Item ID: D350-607-511 Accept ***N900040100*** Setup Start ***NS1***
 Revision ID: Stop ***NS2***
 Item Name: Quick Release Basket and Long Cargo Tube Mounting Provisions, Fits LH or RH
 Start Date: 8/11/15 Start Qty: 2.00 ***2*** Cust Item ID:
 Required Date: 8/19/15 Req'd Qty: 2.00 ***2*** Customer:
 Reference:

DART SERVICE INSTRUCTION

TO AMEND INSTALLATION INSTRUCTIONS D350-607-3 Rev.D,
INSTALLATION INSTRUCTIONS D350-607-4 Rev. C AND
INSTRUCTIONS FOR CONTINUED AIRWORTHINESS ICA-D350-607 REV. 6

A	NEW ISSUE	AJS	14.05.16
REV.	DESCRIPTION	BY	DATE
DESIGN	AJS	DART AEROSPACE LTD HAWKESBURY, ONTARIO, CANADA	
DRAWN	AJS		
CHECKED		DRAWING NO.	REV. A
MFG. APPR.	N/A	DSI 9699	SHEET 1 OF 2
APPROVED		TITLE	SCALE
DE APPR.		LUG REPLACEMENT	NTS
DATE	14.05.16	COPYRIGHT © 2014 BY DART AEROSPACE LTD THIS DOCUMENT IS PRIVATE AND CONFIDENTIAL AND IS SUPPLIED ON THE EXPRESS CONDITION THAT IT IS NOT TO BE USED FOR ANY PURPOSE OR COPIED OR COMMUNICATED TO ANY OTHER PERSON WITHOUT WRITTEN PERMISSION FROM DART AEROSPACE LTD.

FIGURE 1: INSTALLATION OF D4775-041 FWD STRUT

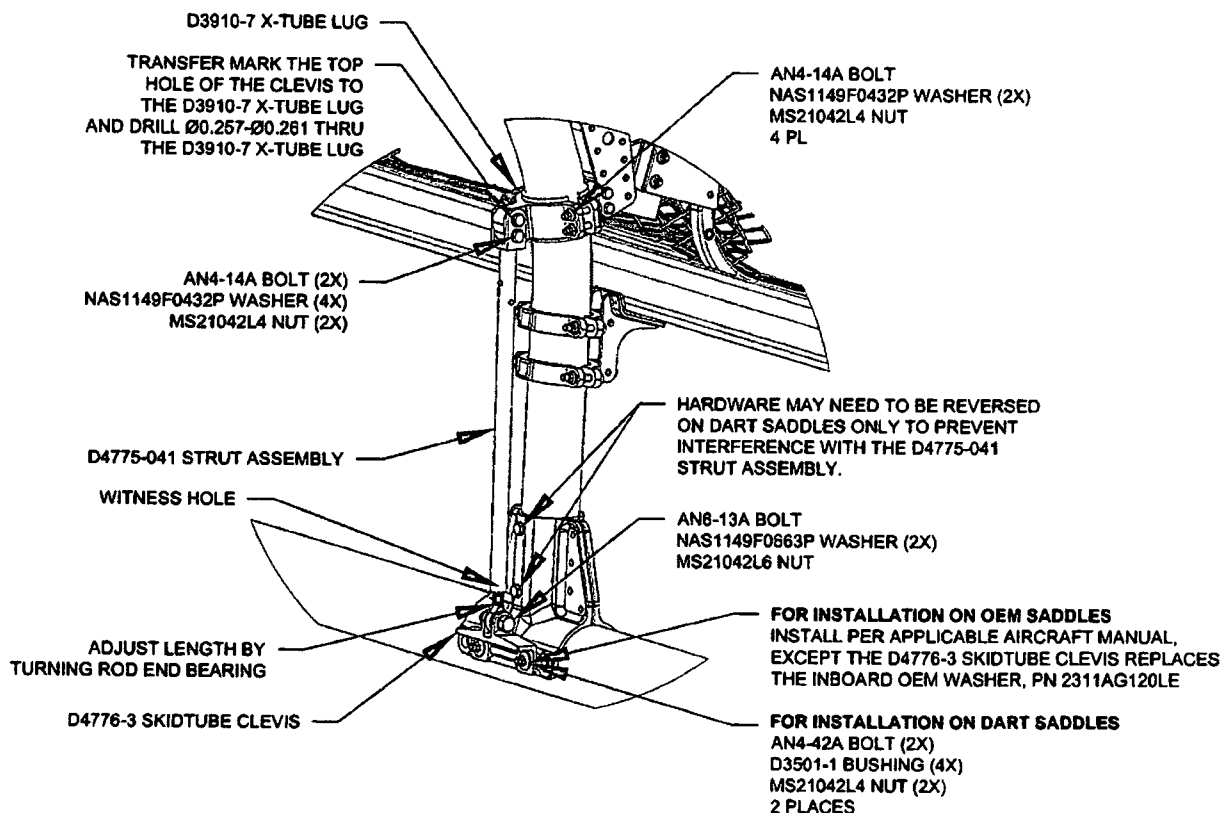
3.1 Substitute the Forward Lower D3910-5 X-Tube Lug with the D3910-7 X-Tube Lug as shown in Figure 1.

3.2 Install the forward D4775-041 Strut Assembly. Transfer mark from the upper hole on the clevis of the D4775-041 Strut Assembly to the D3910-7 X-tube Lug and drill thru the lug $\varnothing 0.257$ - $\varnothing 0.261$ as shown in Figure 1. Touch up chemical conversion coating per MIL-DTL-5541. Check the witness holes located at the bottom end of the D4775-041 Strut Assemblies to ensure that the thread from the rod end extends past the witness hole.
Torque MS21042L4/-4 nuts to 50-70 in-lbs (5.7-7.9 N-m). Torque MS21042L6/-6 nuts to 160-190 in-lbs (18.1-21.5 N-m).
